To:	William Woods, Jenni Austin	Job No:	85452.012
From:	Richard Reinen-Hamill	Date:	31 May 2016
Subject:	CentrePort Harbour Deepening Project - Comments on community queries		
cc:

1 Purpose

Figure 1 Wave roses for P15 and location of p15

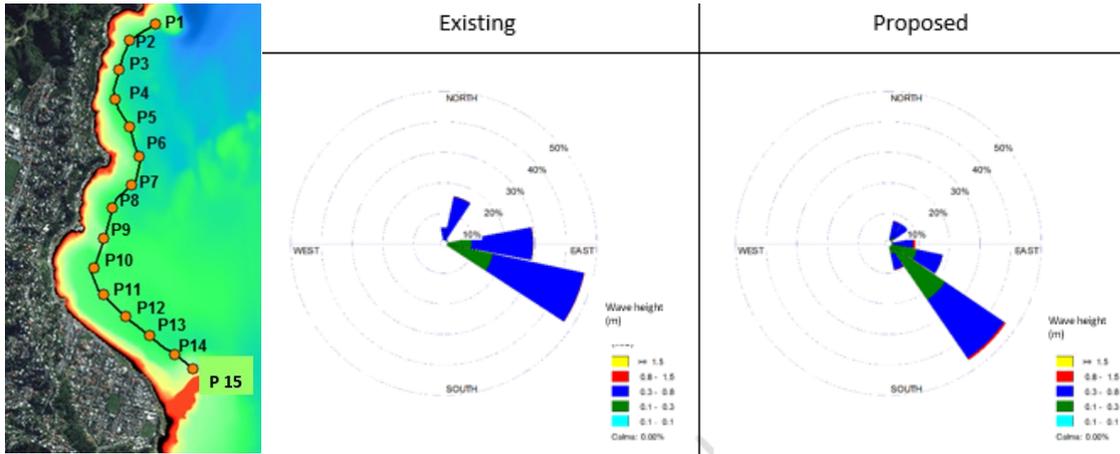
What is the “worst case” prediction for erosion of the beach in the vicinity of the Hector street car park and the playground ...(a) on average...and (b) following storm surges?

The wave roses in Appendix C of our report show that at site P15 (offshore from the area of interest) the peak energy for the typical wave climate (i.e. on average) moves from around 112.5 degrees to 135 degrees as a result of the channel deepening. This means that wave energy becomes more southerly with the dredged channel (refer Figure 1).

Attachment – CG wave output for 1.7 m significant wave height, 11 second period from 170 degrees

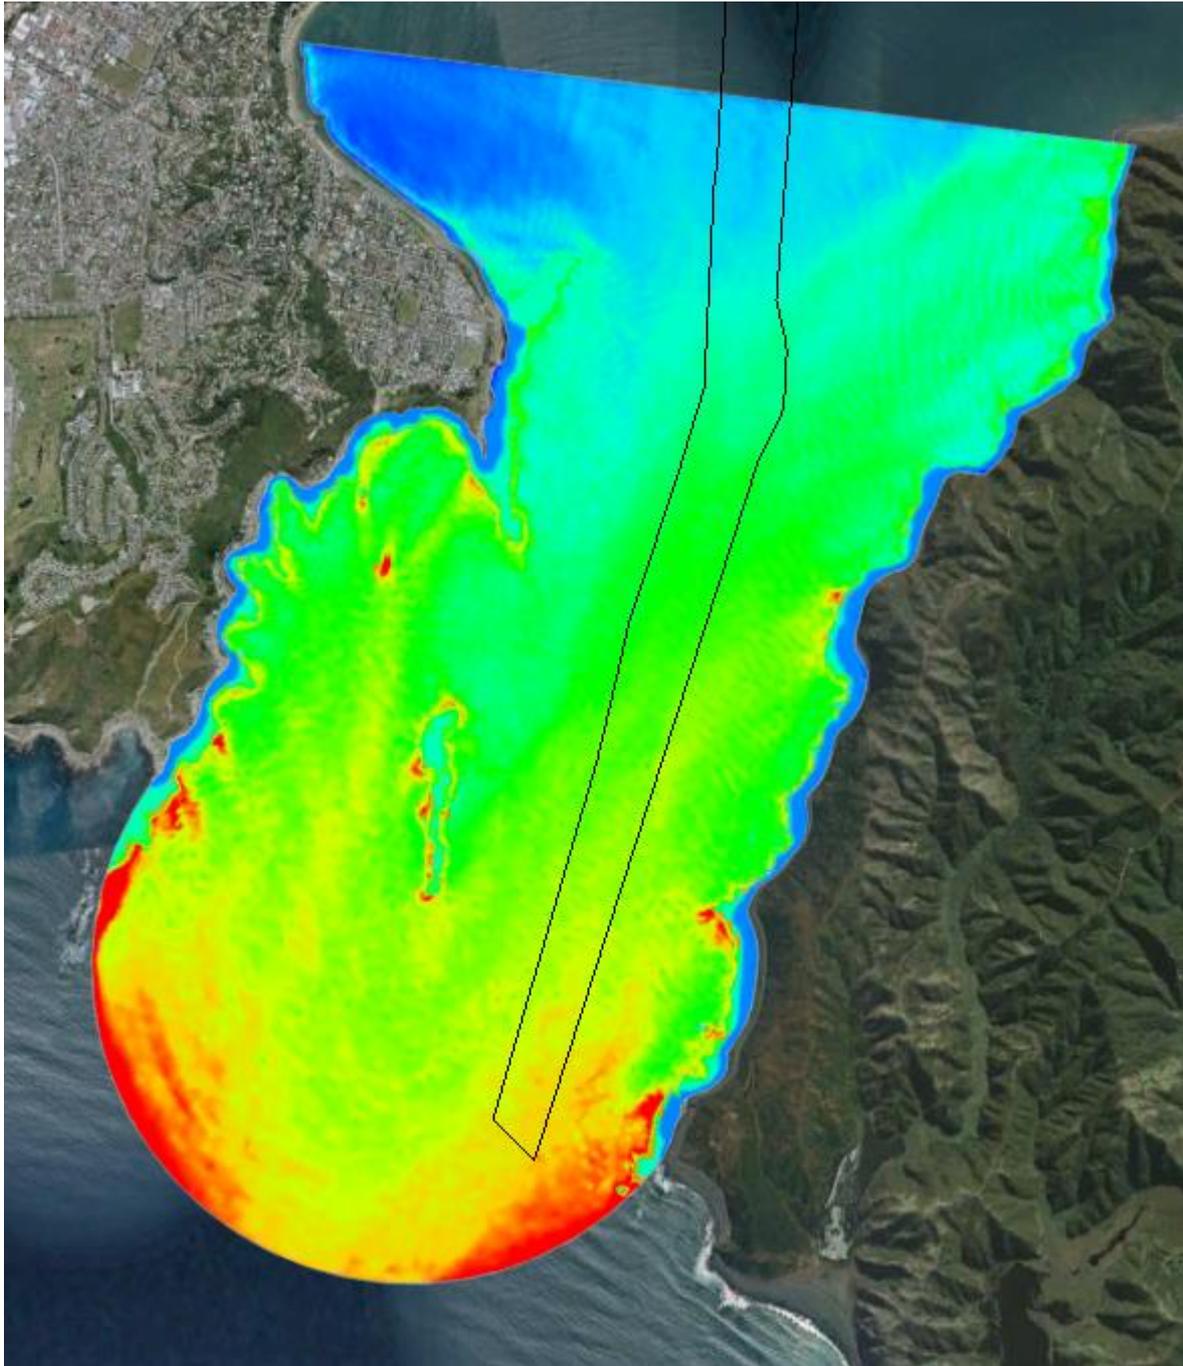
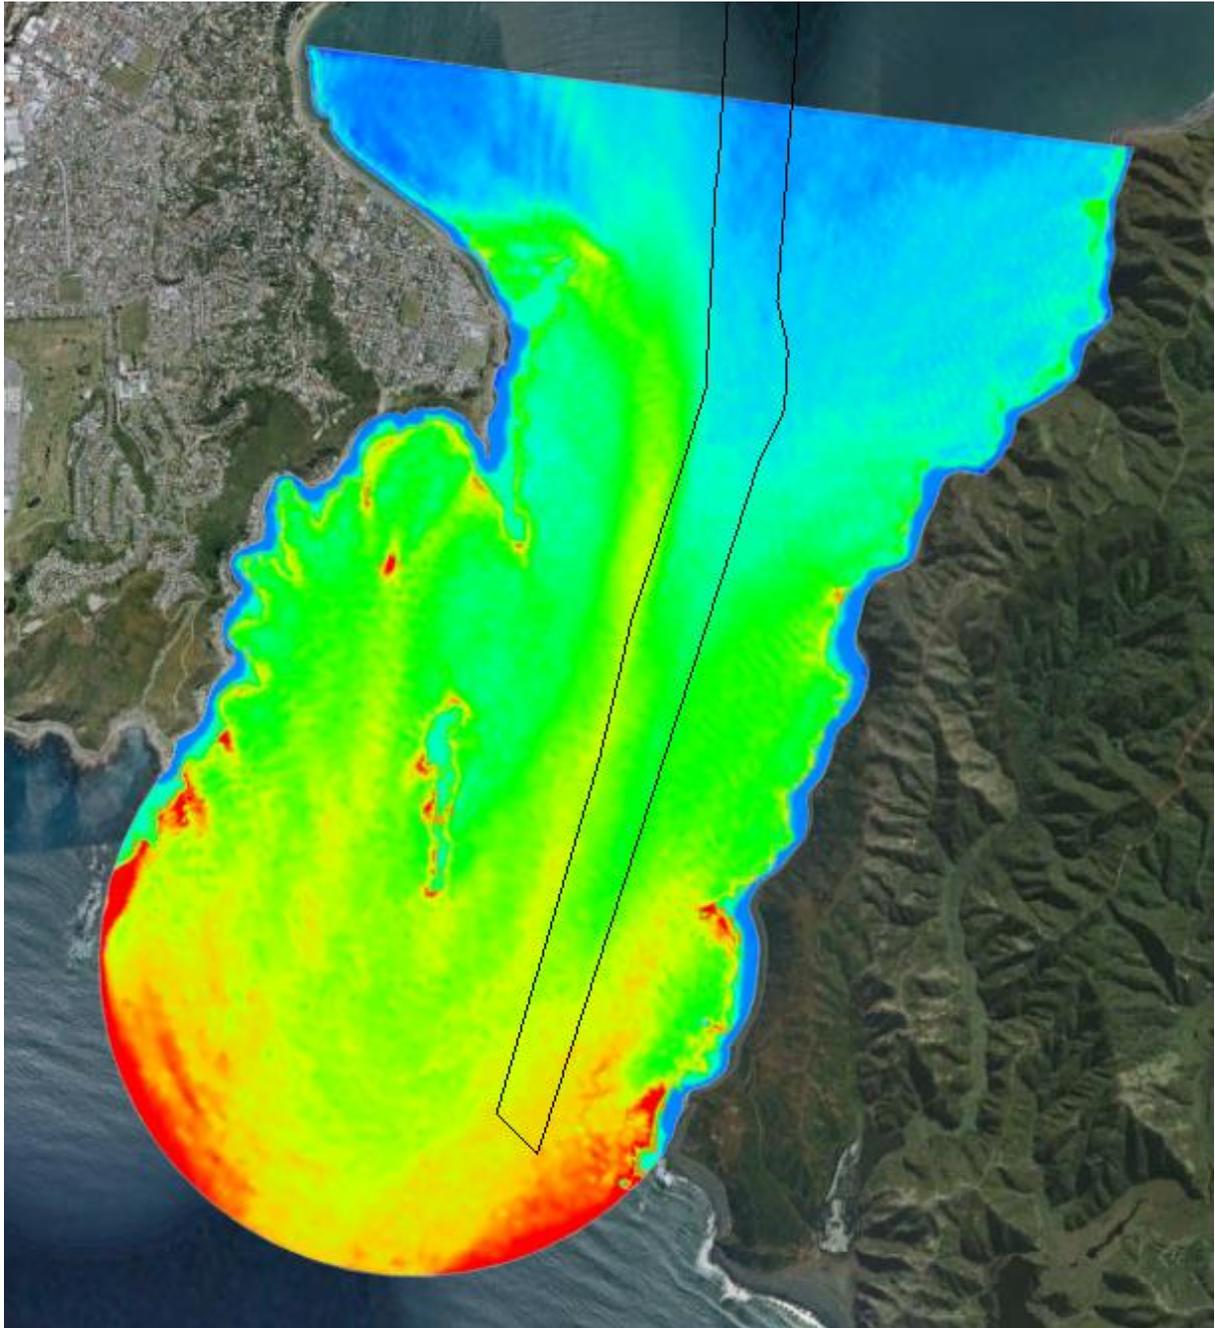
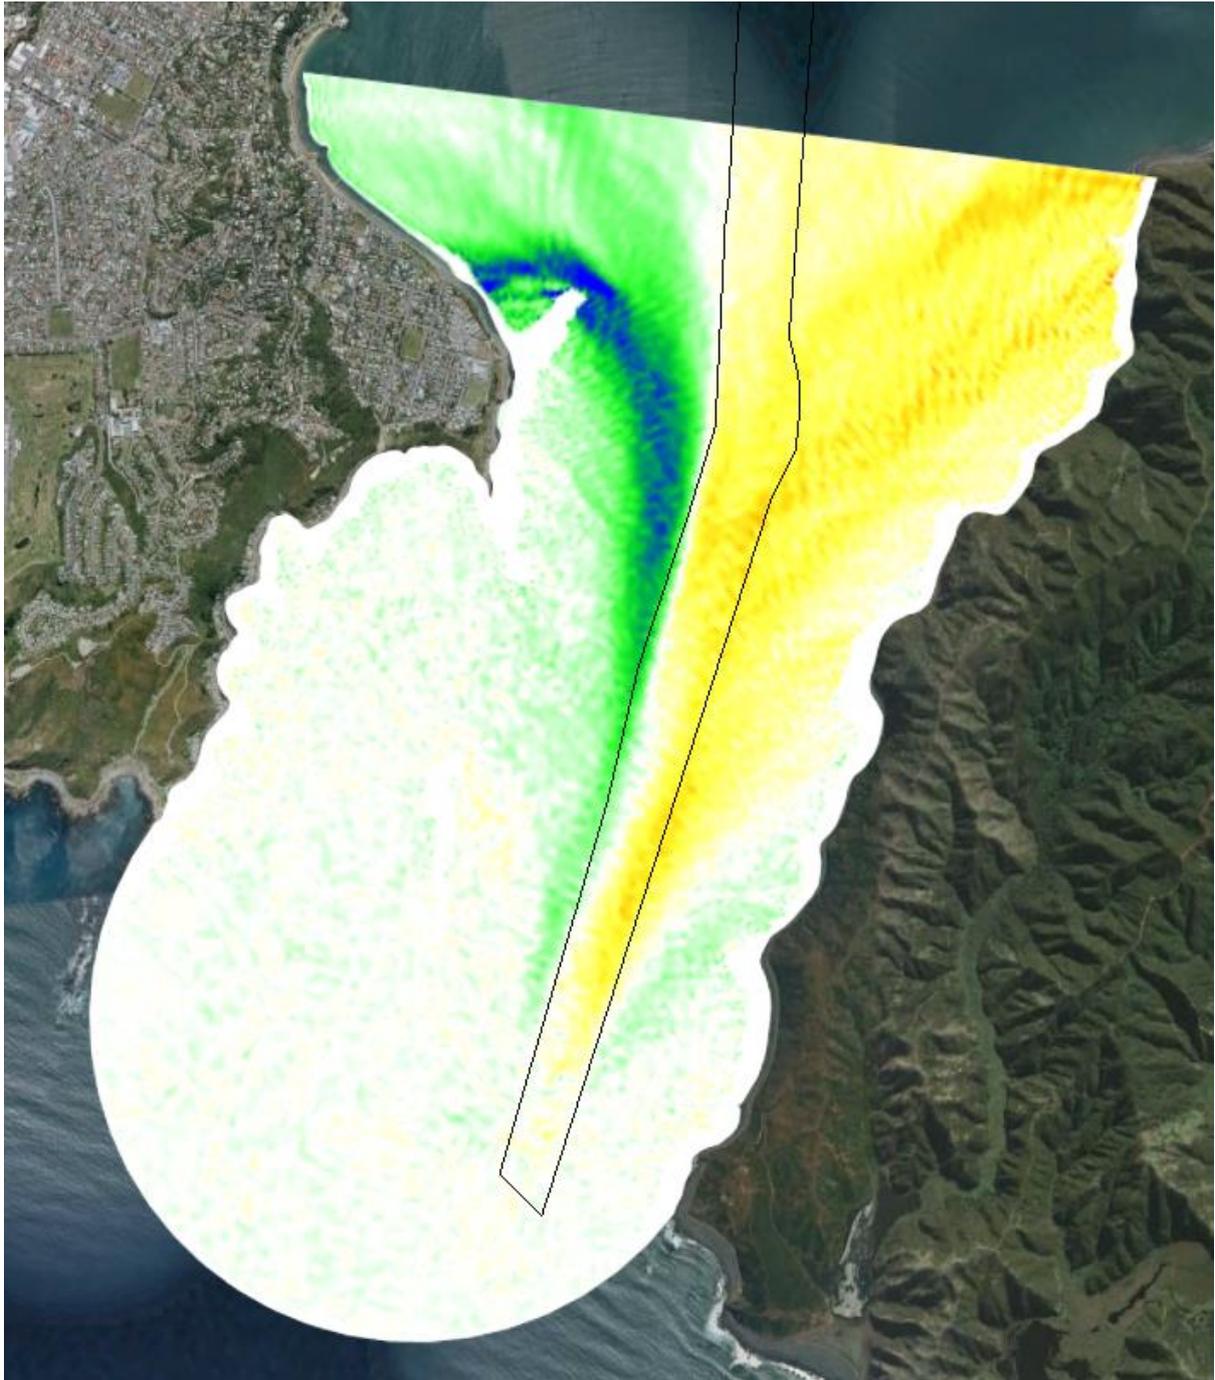
(b) following storm surges

During storm events this location is partially sheltered from southerly swells due to the reef and Steeple Rock. However, as shown in Figure 1, the refraction effects resulting from the dredged channel increase wave energy from 112.5 to 132 degrees during peak storm events. This is shown by the spectral wave analysis included in Appendix A to this memo for a 1.7 m significant wave height with a period of 11 seconds and a direction of 170 degrees for the existing and proposed channel situation. This provides a nearshore wave height in the order of 0.9 m at P15. Wave energy is largely directed onshore during these events due to early refraction with the longer wave periods. This will result in erosion scarps occurring more frequently at the upper part of the beach profile at the area of interest and is likely to increase run-up and overtopping over the beach crest, depending on the state of the beach prior to the storm. It is likely that there may be more frequent inundation of the backshore area as a result of the Project.
